# **Planning Commission Staff Report**

**Project Type:** Site Development Section Plan

**Location:** Spirit of St. Louis Airpark, 600 & 650 North Bell Avenue

Description: Spirit of St. Louis Airpark, North Bell Hangars: A Site

Elevations that were presented at the July 14, 2011 Architectural Review Board meeting.

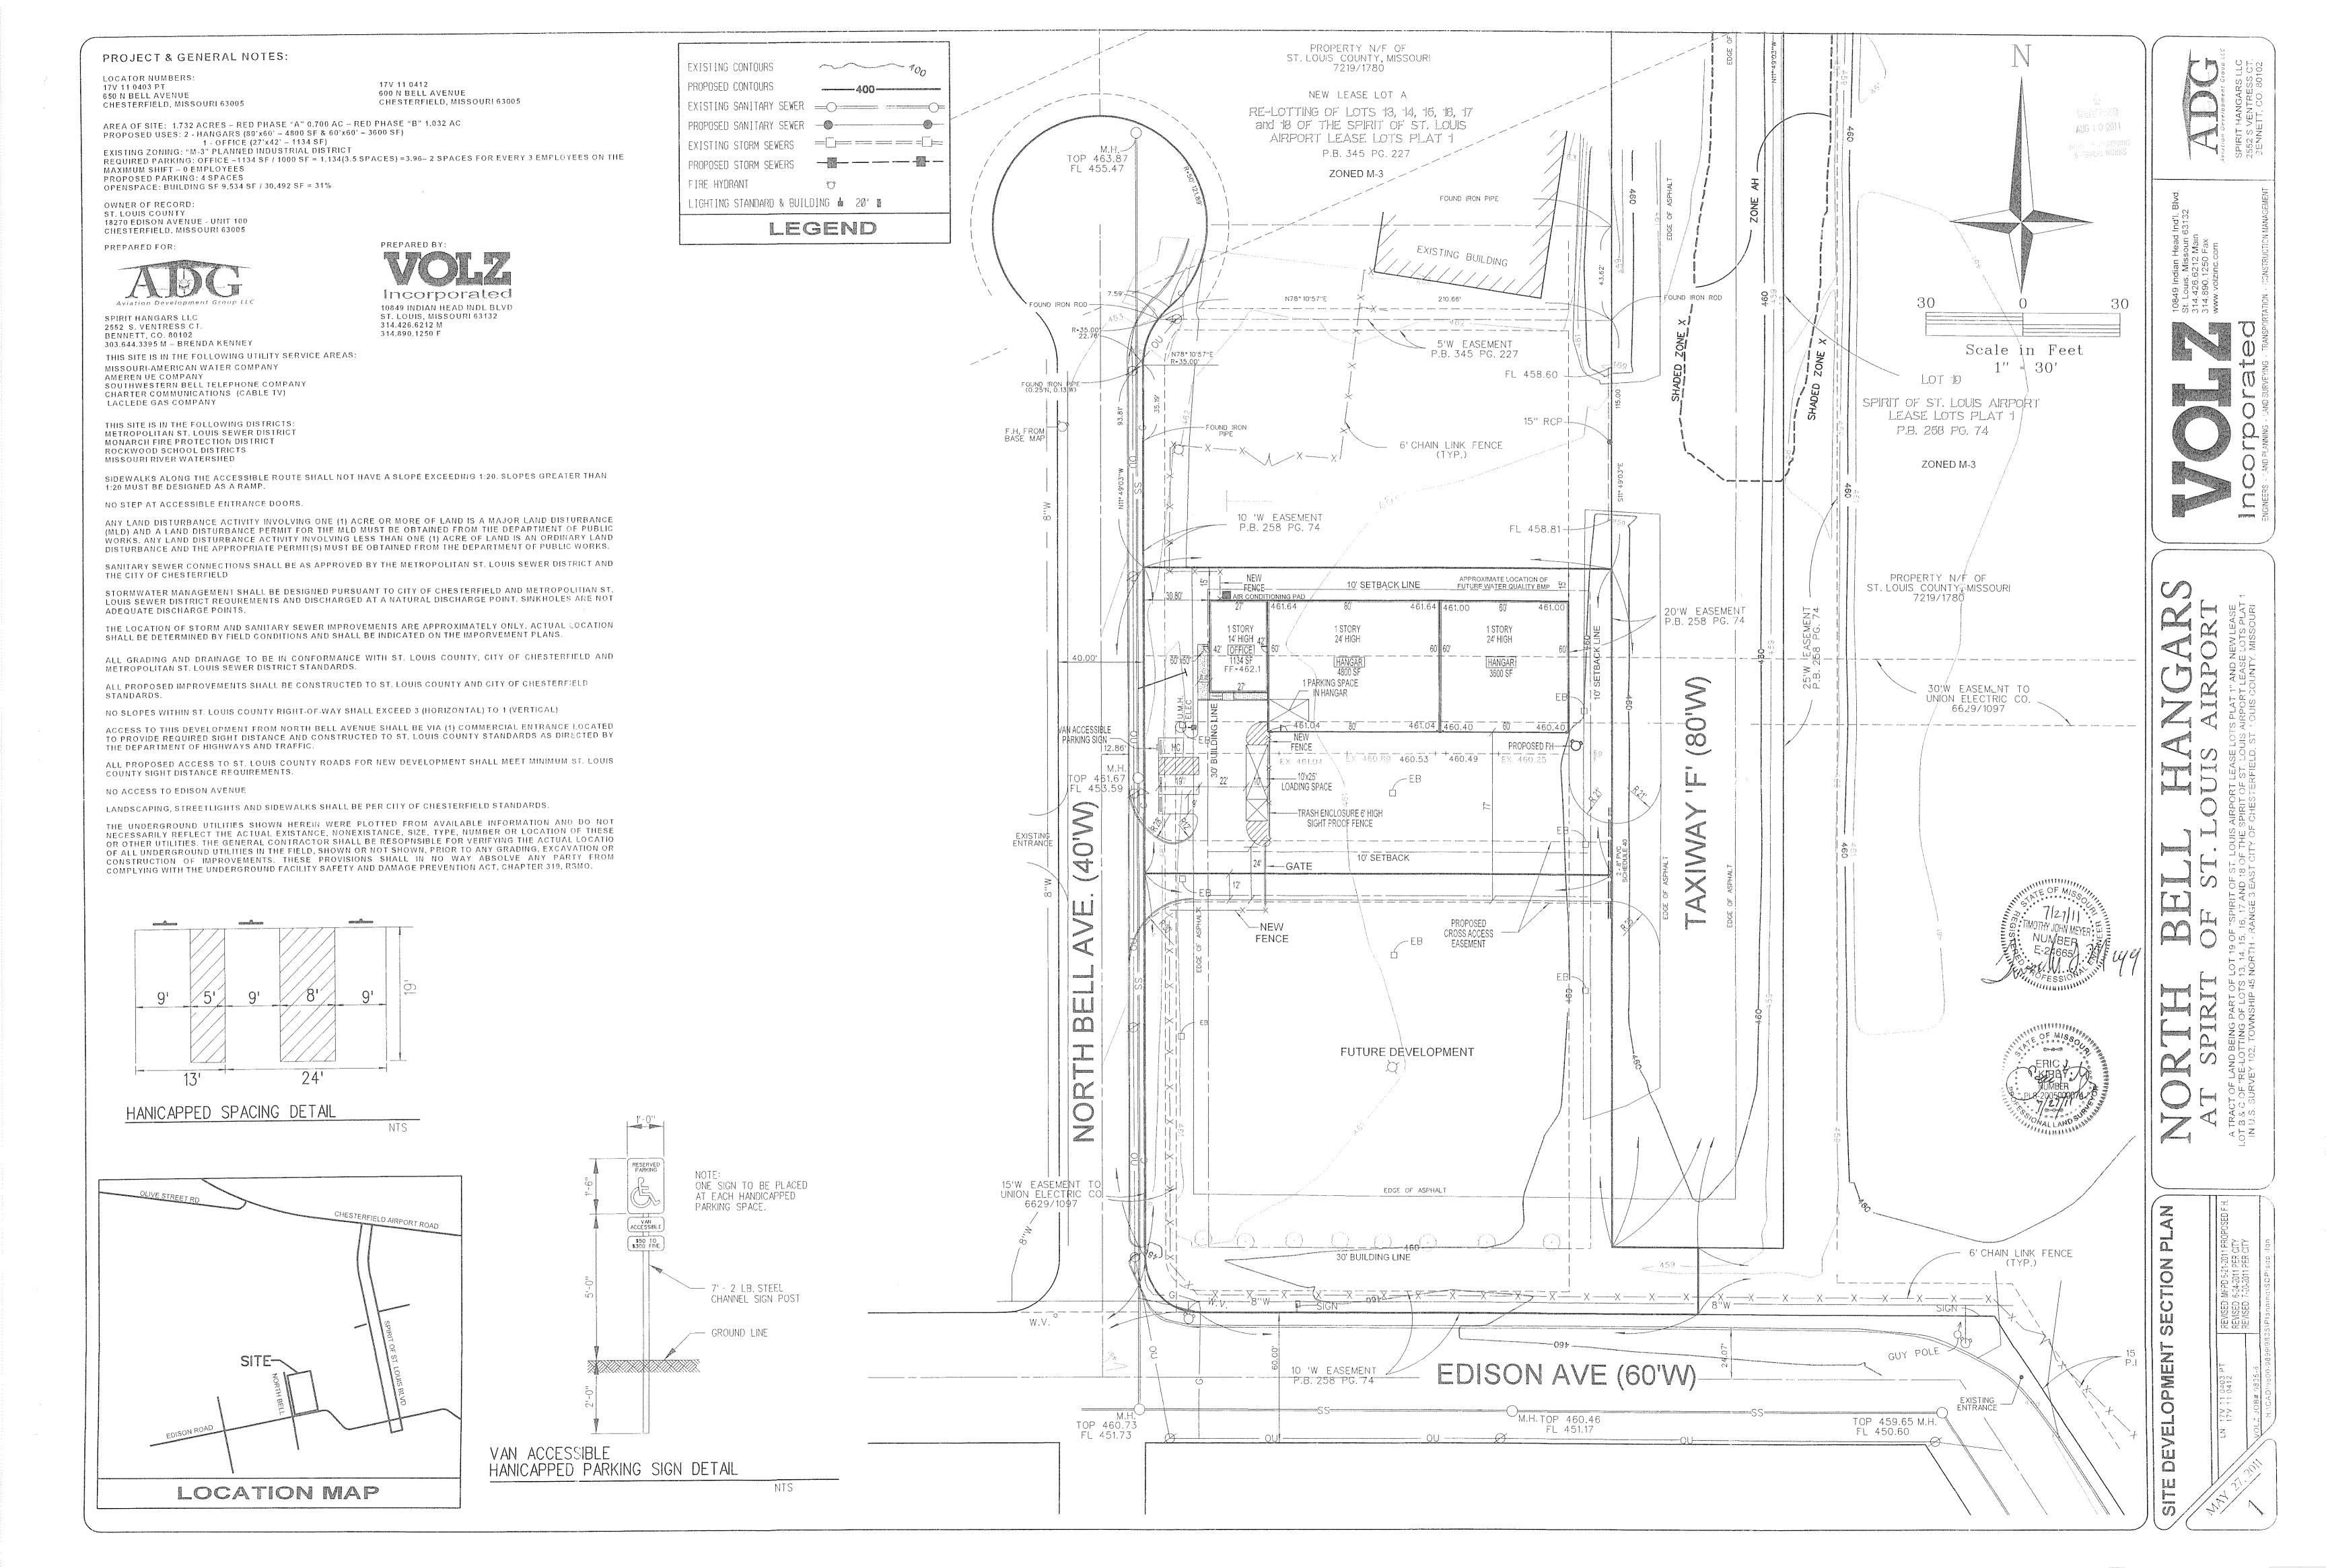
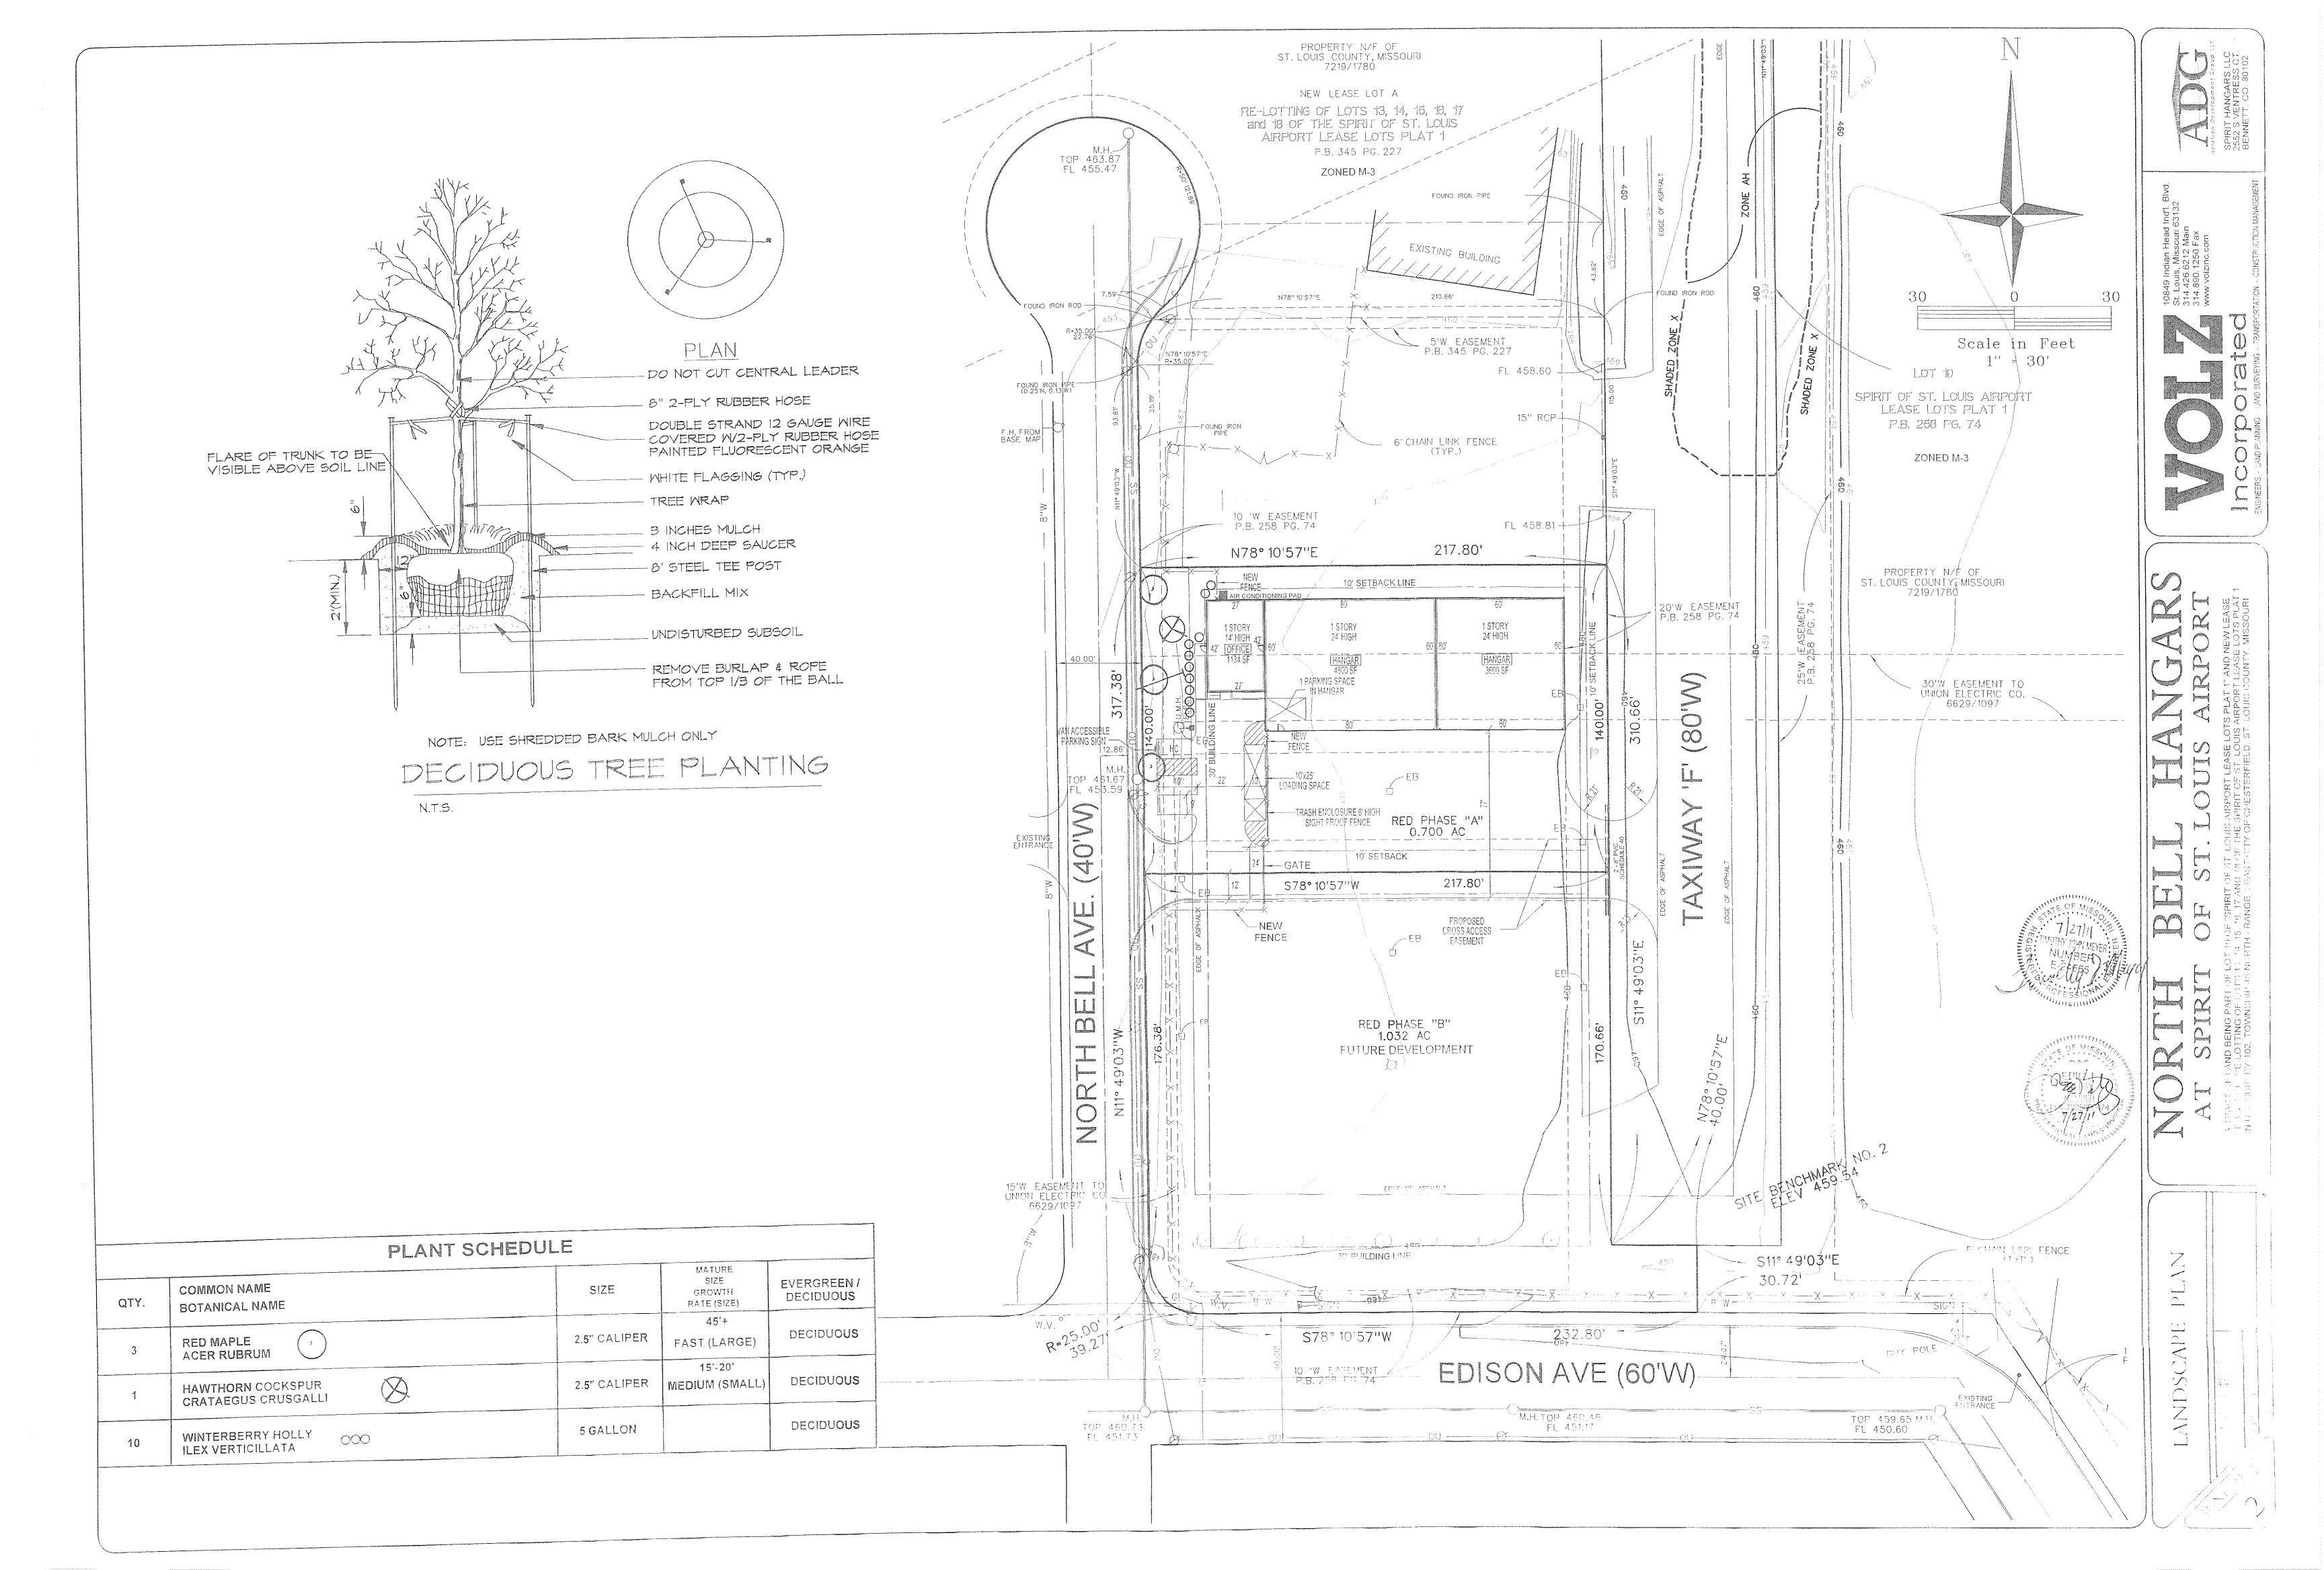
1. The west and south facades of the office portion of the building need to have some additional architectural detailing, delineation, change in materials or an adjustment in the roofline that is consistent with the Architectural Standards.

- The Architect added a series of low-lying shrubs along the walkway leading to the office entrance.
- 3. Screening of the HVAC equipment is to be addressed.

- Low-lying shrubs have been utilized to screen the HVAC equipment which is located on the northern side of the office.
- 4. Encouraged the petitioner not to use a painted, hollow metal door for the facility.

- The Architect opted to utilize an aluminum storefront entrance in lieu of the painted, hollow metal door.
- 5. Consideration of possibly adding a canopy that will distinguish the entranceway and to provide architectural interest.

In addition to addressing the comments by the Architectural Review Board, the Architect opted to change the color scheme of the facility to match the color schemes of the surrounding hangars. The original proposal was of an earth tone nature with a combination of light browns, dark browns and whites. The new elevations use a series of gray tones and white with a small red band detailing the office portion of the facility. The following figures display the changes:

- The Architect added a red band across the roofline of the office portion of the facility.
- 2. Recommend adding low level landscaping to enhance and give a sense of entry to the building approach.

- Canopies are required to meet structure setback requirements. At this location, a canopy would encroach into said setback.
